Technical Report

No. 13618

Engineering Evaluation of the MEMCOR Small ROWPU

February 1995

Encl

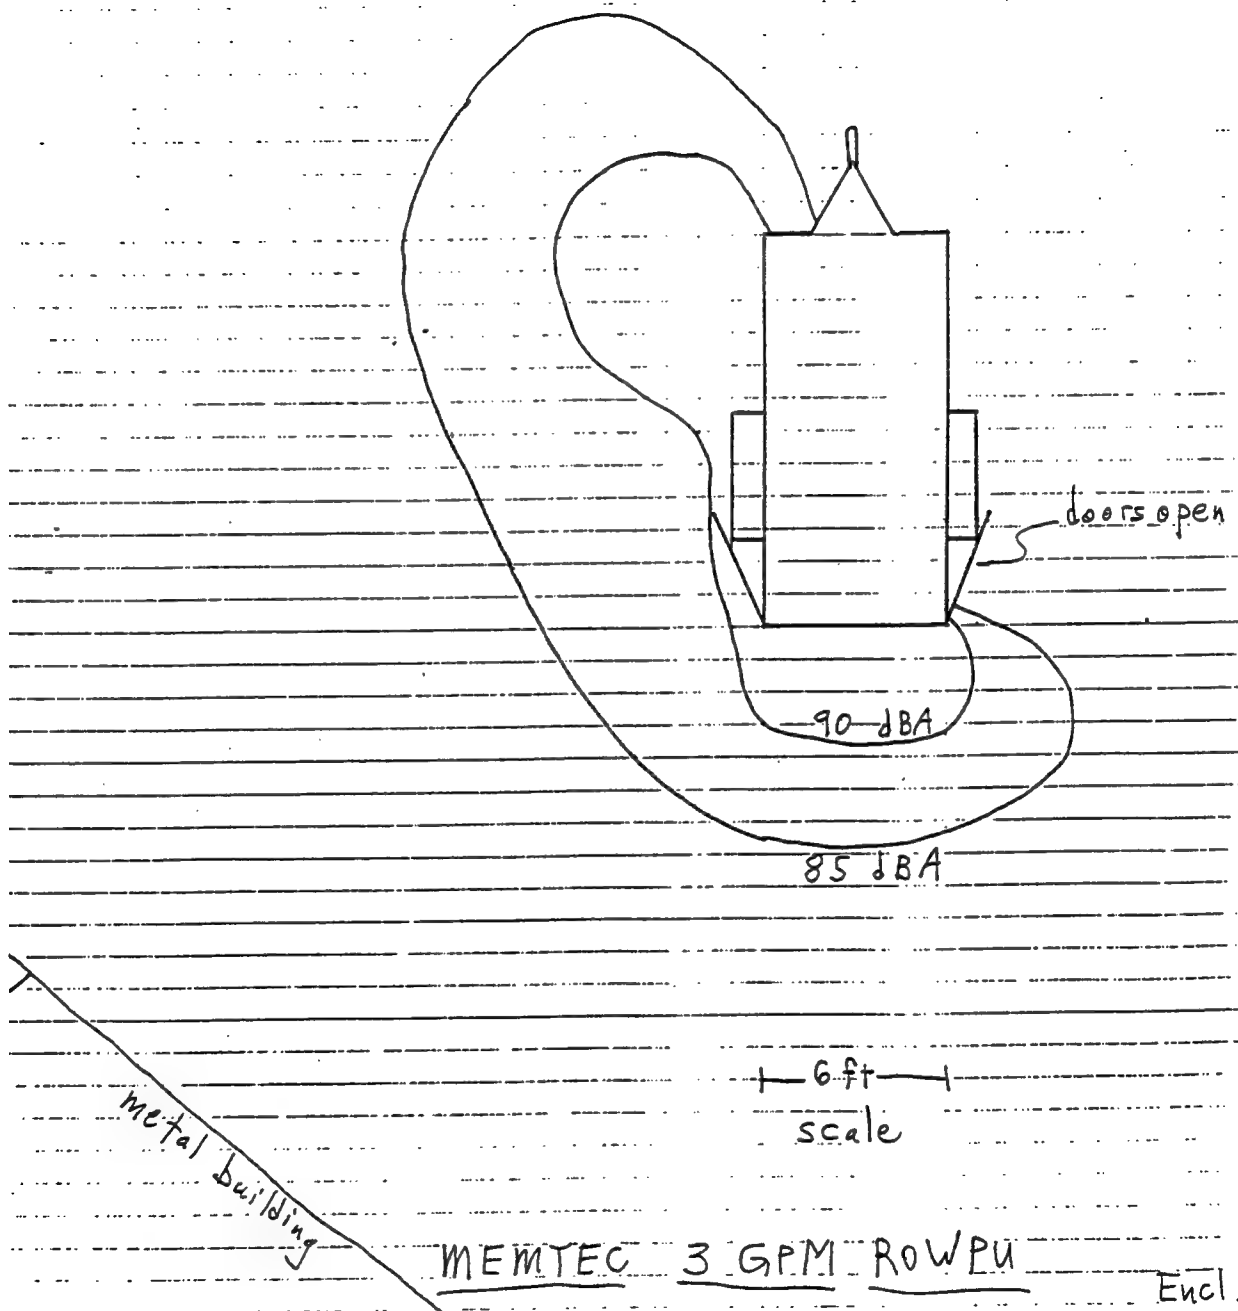
4. Acoustical Noise - Para 3.3.6.1.
 - a. Exterior noise levels of 85 dBA extend a maximum distance of 11 feet 6 inches from the exterior of the trailer with all doors open. For 85 and 90 dBA noise contours, see Encl 1.

Figure 1. Display heights. This front view sketch is not to scale. The generator gauges are directly above the meters and switches deep under the RO vessels.

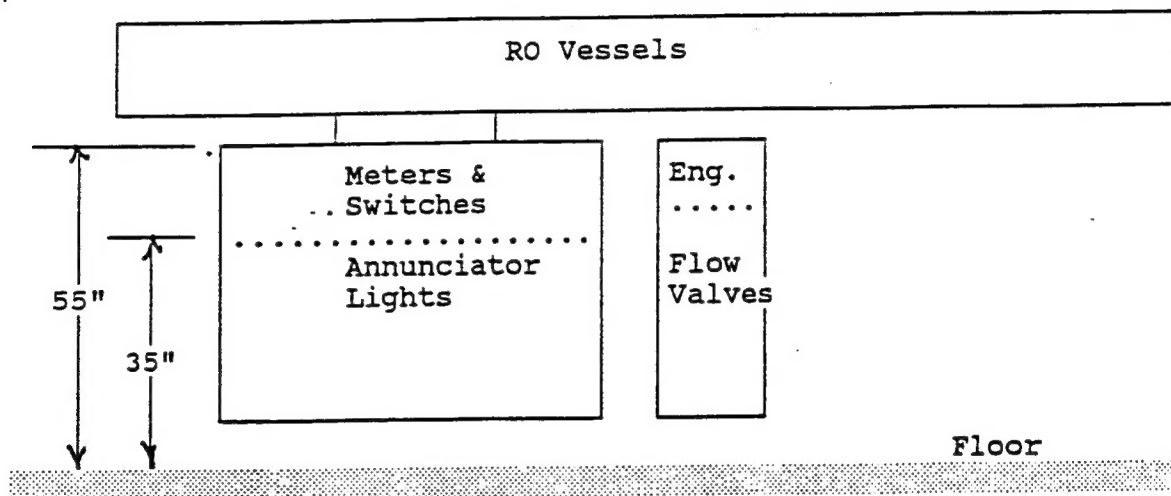
m. Controls are not located at eye height (see Figure 1). The engine portion is not labeled properly. Illumination on the control panels is wholly insufficient and poorly distributed. The generator meters are buried under the Reverse Osmosis (RO) vessels and have scales that are hard

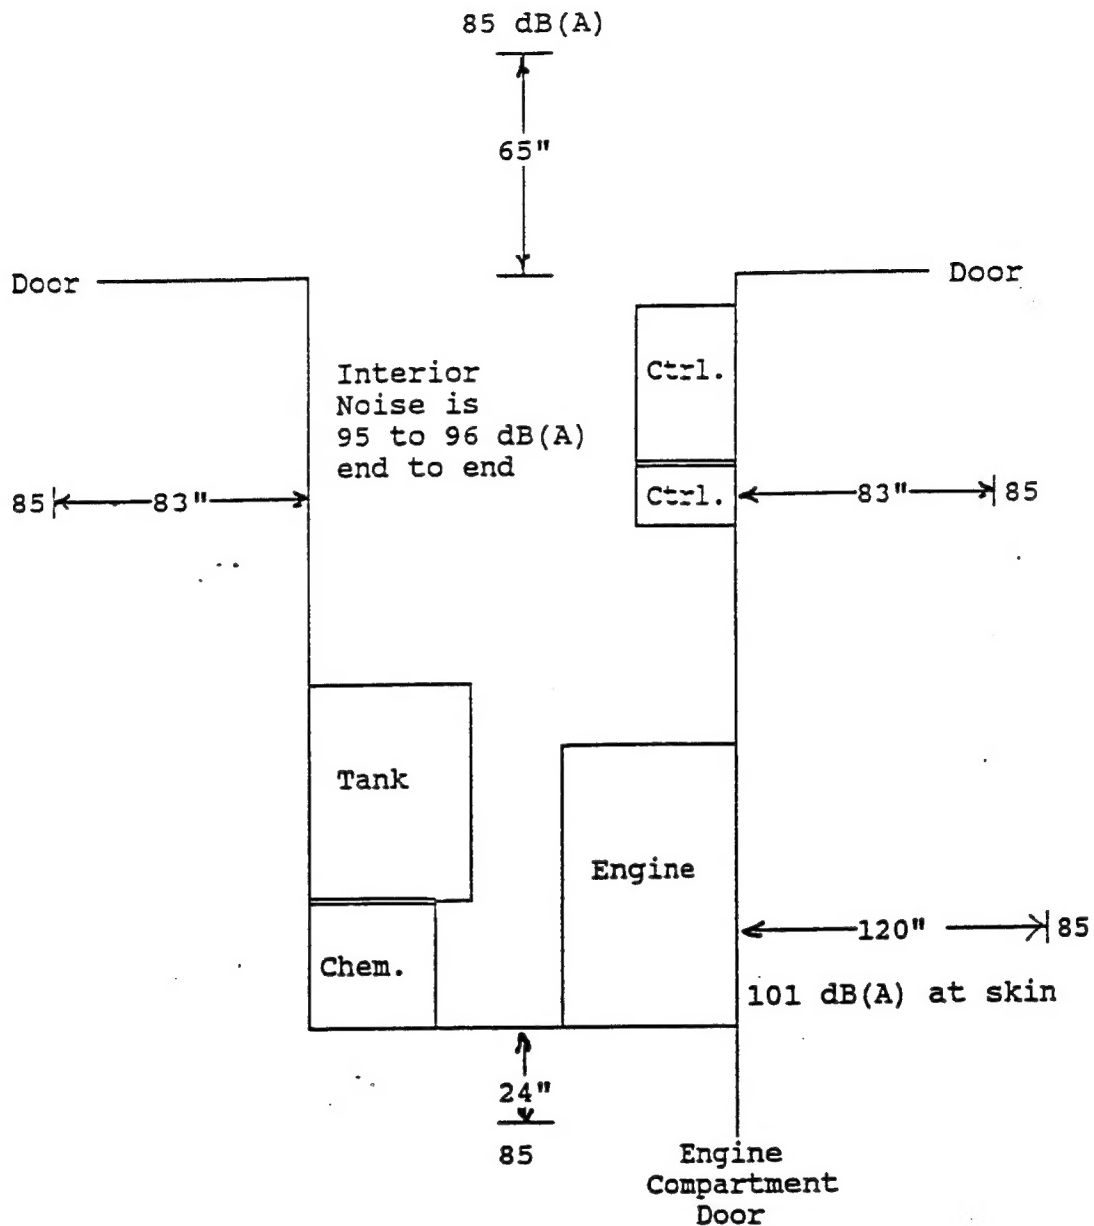
a. Figure 2. lists internal and external noise levels which vastly exceed MIL-STD-1474C (Tri-Service) requirements. Interior levels of 95 to 96 dB(A) cause a 23% hearing damage risk level. Exterior levels also exceed the commonly required 85 dB(A) at 1 meter level. Hearing damage hazard signs are not posted. Thus, personnel are not warned of the hazard. Hearing loss compensation cost the Army more than \$2 billion since 1968. So, controlling the hazard at the source, rather than hoping that warning signs will suffice, is prudent.
